Piper Aircraft Corporation  
Vero Beach, Florida, U.S.A.

# SERVICE No. 933A BULLETIN

Trunnion Replacement

SKETCH "A"

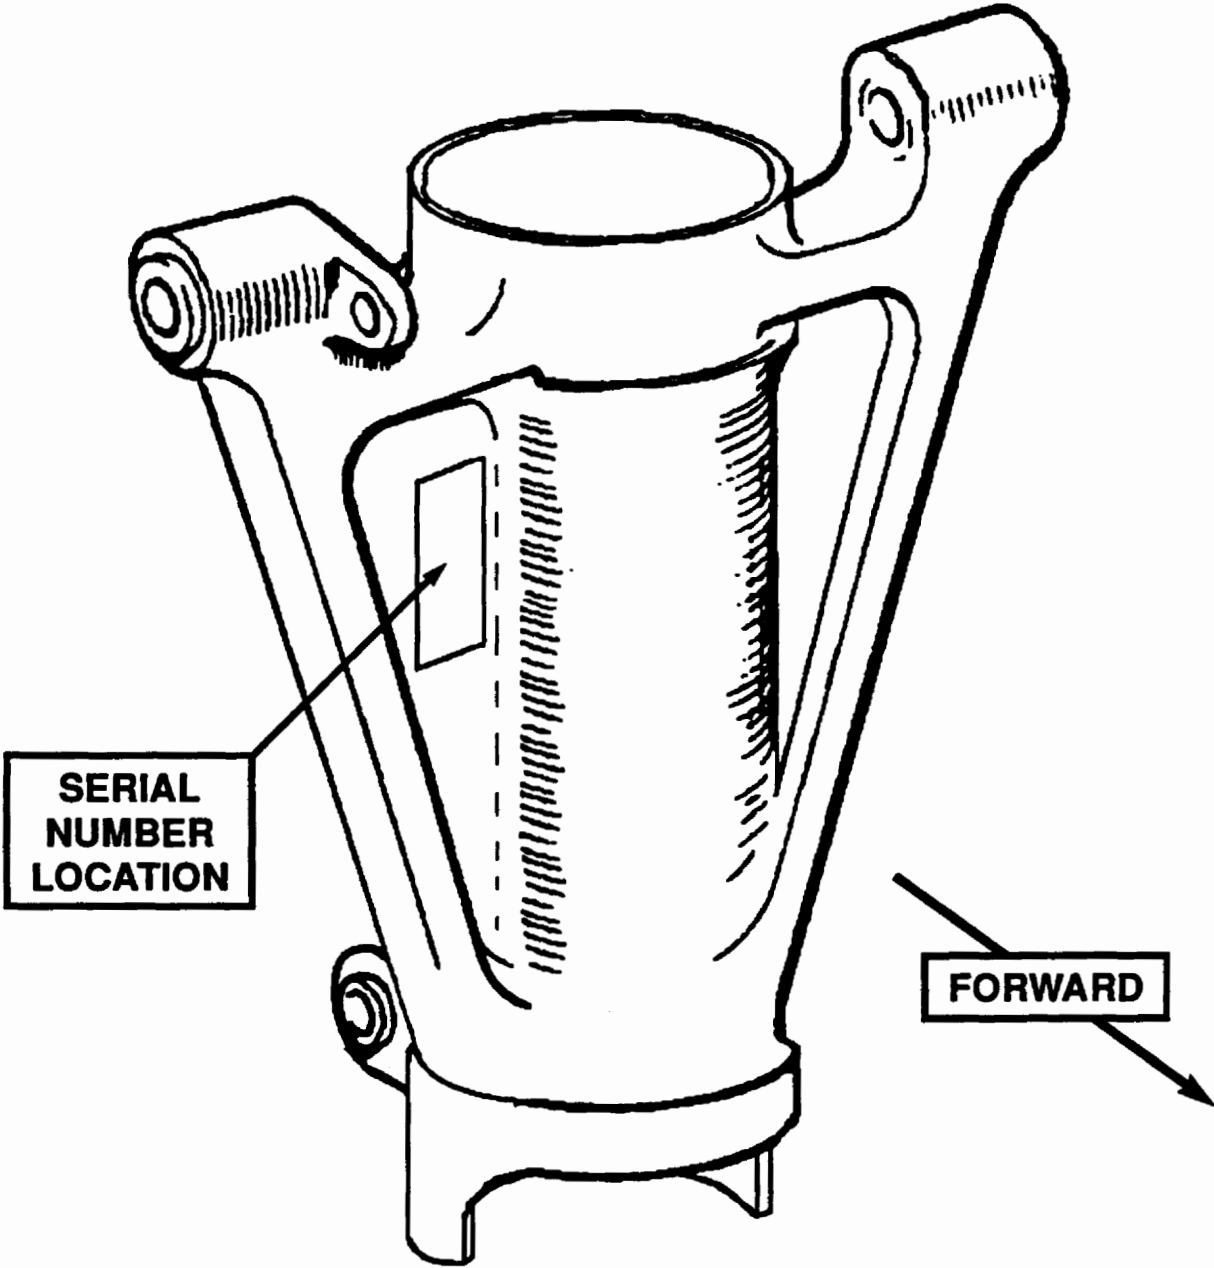
1. Locate serial number etched on the nose gear trunnion. (See Sketch "A") This is located on the front of the trunnion on the left web as you look aft.

2. If the serial number falls between 15200 through 15313, the trunnion must be removed from service. Replace with Nose Gear Trunnion, Piper Part Number 67054-003 with serial number not in the effected range.
3. If the nose gear trunnion requires replacement, place aircraft on jacks and refer to the appropriate Service Manual for instructions and procedures for removal and reinstallation.
4. Following the nose gear trunnion replacement, perform gear retraction cycle check per appropriate chapter of the Maintenance Manual. Upon successful completion, remove aircraft from jacks.
5. Make an appropriate logbook entry of compliance with this Service Bulletin.
